Access Compliance Report

Public Rights-of-Way

Intersection ID: 16436	Main Street: HAMPTON_AV	Cross Street: PORTLAND_AV	Location: NE
ADA ID: 6DA0BBBDAA5A	Ramp Type: PerpDiag	Initial Pass/Fail: Fail	Overall Compliance: No
		Severity Score: 10

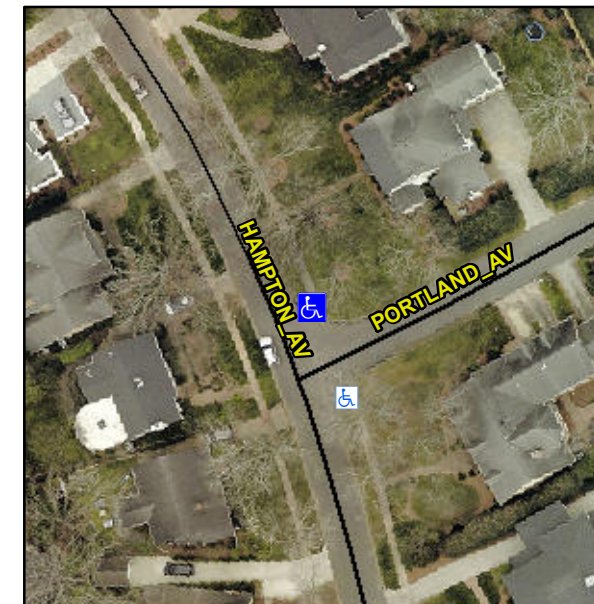
Not Found, R304.5.1, R304.5.3

Compliance	Description	Data	Compliance	Description	Data
N/A	Ramp Length (in)	84.0	Yes	Ramp Slope (%)	6.5
No	Ramp Width (in)	45.0	No	Ramp XSlope (%)	2.7
N/A	Flare Type LT	N/A	N/A	Flare Type RT	N/A
N/A	Flare Slope LT (%)	N/A	N/A	Flare Slope RT (%)	N/A
N/A	Flare Traversable LT?	N/A	N/A	Flare Traversable RT?	N/A
N/A	Landing Length (in)	N/A	N/A	DWS Provided?	N/A
N/A	Landing Width (in)	N/A	N/A	DWS Contrast?	N/A
N/A	Landing Slope (%)	N/A	N/A	DWS Length (in)	N/A
N/A	Landing X Slope (%)	N/A	N/A	DWS Full Width?	N/A
N/A	Landing Curb? (Y/N)	N/A	N/A	DWS Offset (in)	N/A
N/A	Shared Landing?	N/A			
N/A	Gutter Ponding?	N/A	N/A	Gutter Slope (%)	N/A
N/A	Gutter Lip Ht (in)	N/A	N/A	Gutter X Slope (%)	N/A
N/A	Painted X Walk1?	No	N/A	Painted X Walk2?	No
	X Walk 1 Direction	To W		X Walk 2 Direction	To S
N/A	X Walk 1 Width (in)	N/A	N/A	X Walk 2 Width (in)	N/A
	X Walk 1 Slope (%)	3.7		X Walk 2 Slope (%)	0.5
	X Walk 1 X Slope (%)	0.1		X Walk 2 X Slope (%)	0.1

Remove & Replace Curb Ramp With Two New Directional Ramps or Equivalent.
